UNITED STATES PATENT AND TRADEMARK OFFICE

APPLICATION NO.	FILING DATE	FIRST NAMED INVENTOR	ATTORNEY DOCKET NO.	CONFIRMATION NO.
10/607,679	06/26/2003	Li-Peng Wang	42.P16640	8027

Office Action Summary

DETAILED ACTION

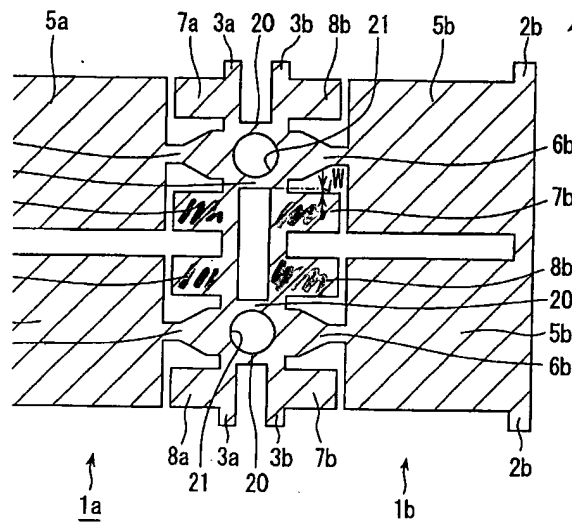
5. In response to applicant's argument that Kaneda fails to disclose the heat transfer layer surrounding, but not in contact with the electrodes, electrodes, it is shown in figure 9 a heat sink 5 (yellow) surrounding the electrodes 7a, 7b, 8a and 8b (green) as shown in the figure below.
